World Forum for Harmonization of Vehicle Regulations

Eightieth session Geneva, 15–18 September 2015 Item 3 of the provisional agenda Regulations Nos. 13 and 13-H (Braking)

Proposal for amendments to Regulation No. 13 (Heavy vehicle braking) and 13-H (Brakes of M_1 and N_1 vehicles)

Submitted by the expert from Germany*

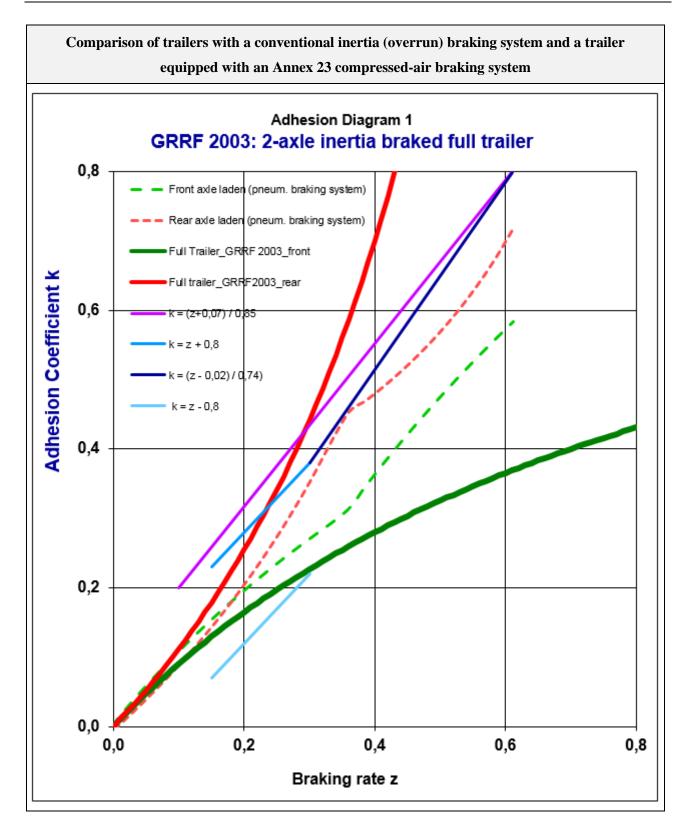
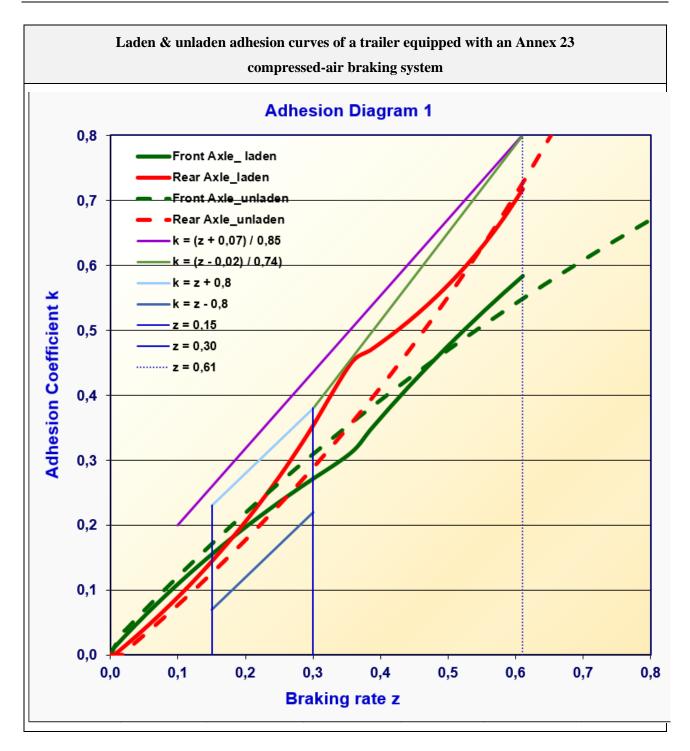
26. These curves have been calculated from an O_2 full trailer (mass 3500 kg - E = 2.80 m - hR = 1.5 m) with a symmetrical brake force distribution. These curves are typical for full trailers with conventional inertia (overrun) braking systems according to Annex 12. The adhesion utilization curve of the rear axle lies (contrary to the philosophy of Annex 10) above that of the front axle over the whole deceleration range.

27. The dotted red (rear axle) and dotted green (front axle) curves are the adhesion utilization curves calculated from the O_2 full trailer (test vehicle data see in this Justification, paragraph "General" of Annex 23) equipped with an Annex 23 compressed-air braking system (according to paragraph 3.1. of Annex 23) fitted with pressure regulating devices. These adhesion utilization curves are complying with the requirements of paragraph 5.1. of Annex 10 (see also the next diagram but one).

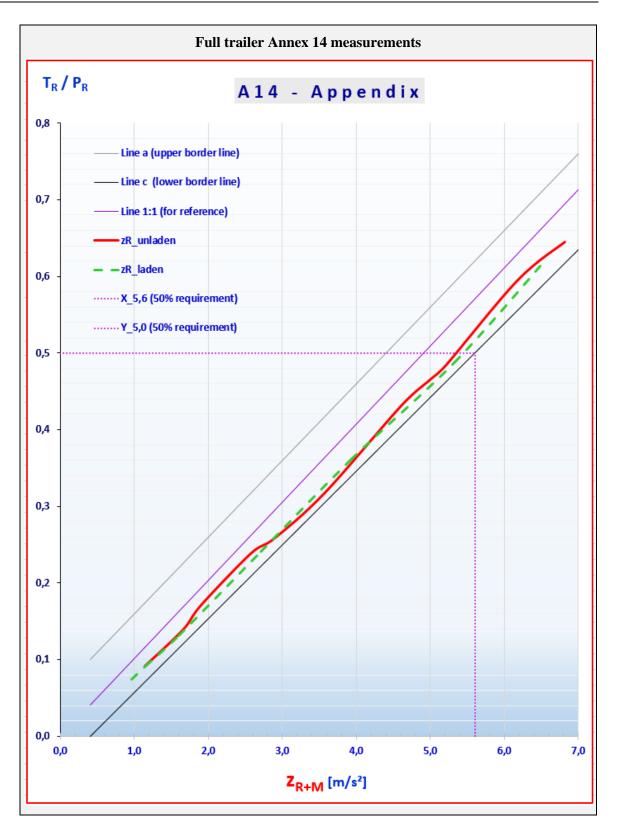
89. The following diagram shows the positive test results of the tests carried out according to Section 3 of Annex 14. The variance of the measured coupling forces between the towing vehicle and the trailer has a bigger effect in the unladen state than in the laden state.

90. These test results had been obtained with a prototype test trailer according to paragraph 3.1. It is assumed that the characteristics of the mechanical control device can be optimised leading to smaller coupling forces which would move both characteristic lines even closer to the ideal 1:1 reference line.
